PALO VERDE NUCLEAR GENERATING STATION

SAFETY PARAMETER DISPLAY SYSTEM

SAFETY ANALYSIS REPORT

February, 1985

FIGURE 3-1 TOP LEVEL SPD

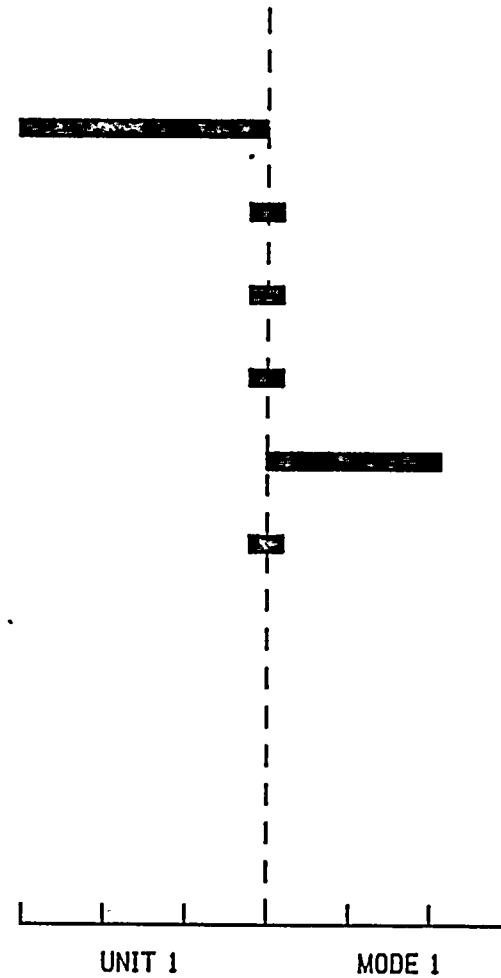
4. Top Level RTV Bar: CEA drop causes a right deflection. When all CEA's are down the SPD should be normal.
Response: This item was closed out by changing the algorithm for this bar and has been verified to function properly.

6. Wrong names on Top Level display.
Response: This item was closed out by making the Top Level SPD match the plant specific safety function groups.
7. Wrong group of parameters.

9. Need number on top level SPD to access lower level display SPD's.
Response: A number adjacent to each top level SPD parameter has been provided to ease in accessing lower level SPD's. The lower level SPD's have also been provided with a number to assist in accessing trend plots.

FIGURE 3-3 THIRD LEVEL SPD (TREND PLOTS)

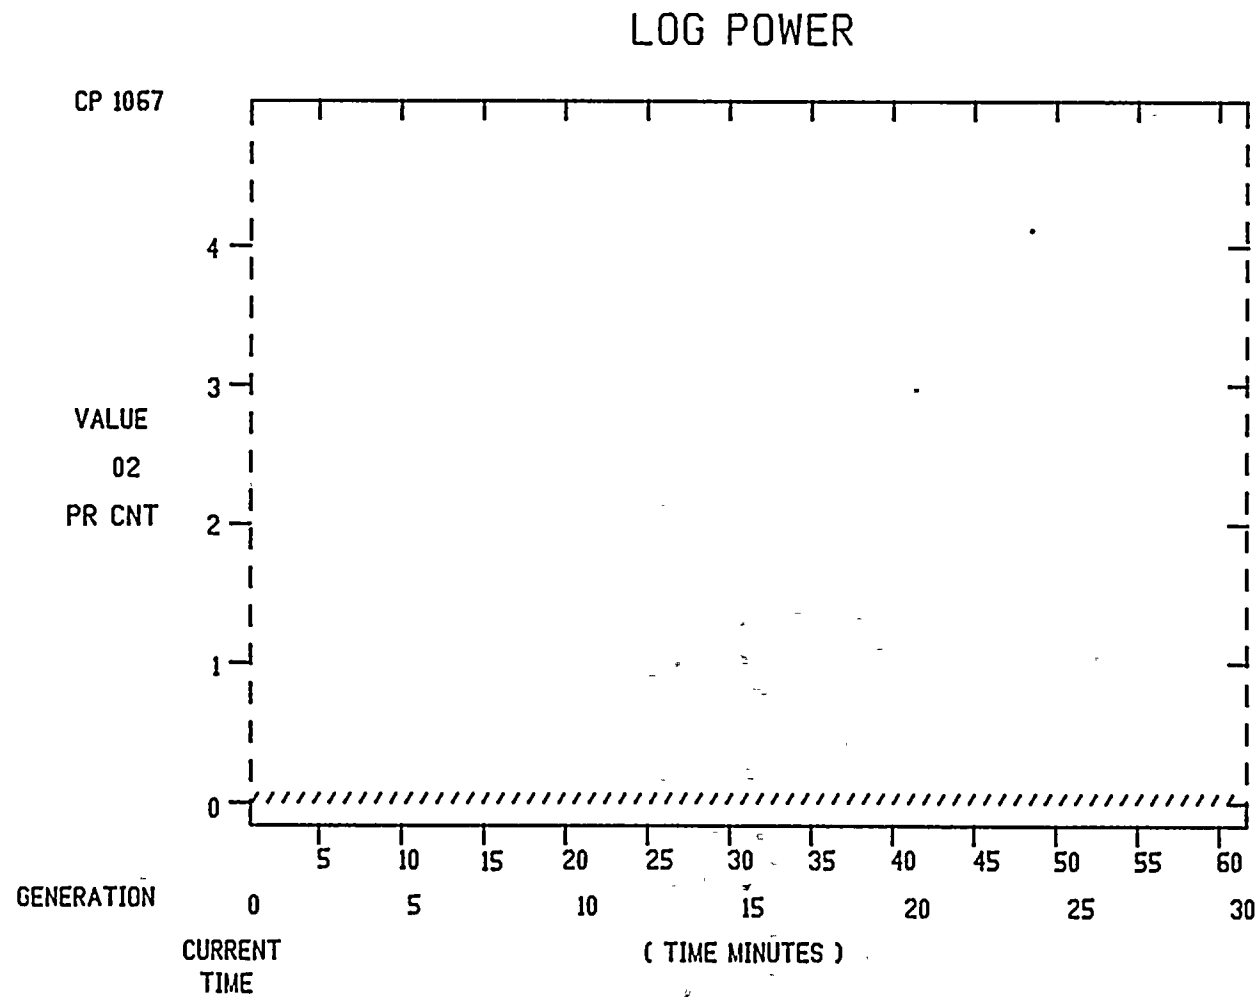
Response: Display labeling will be modified to indicate its a "Delta" temperature.
- SPO 4. Trend plots do not page forward and several x-y axis borders are missing. (80, 81)

- SPO 7. Modacs 75 mv cards were improperly scaled as 100 mv. (94)
Response: This software problem will be corrected by providing correct scaling.
- SPO 8. Trend plots should provide autoscaling in the vertical direction on a logarithmic scale. (95)

Response: The RMS/ERFDADS link will be tested.
- SPO 22. Trend plots do not indicate a validity error. (109)
Response: This observation will be corrected by indicating invalidity of trend values. The invalidity indication has been verified satisfactorily.
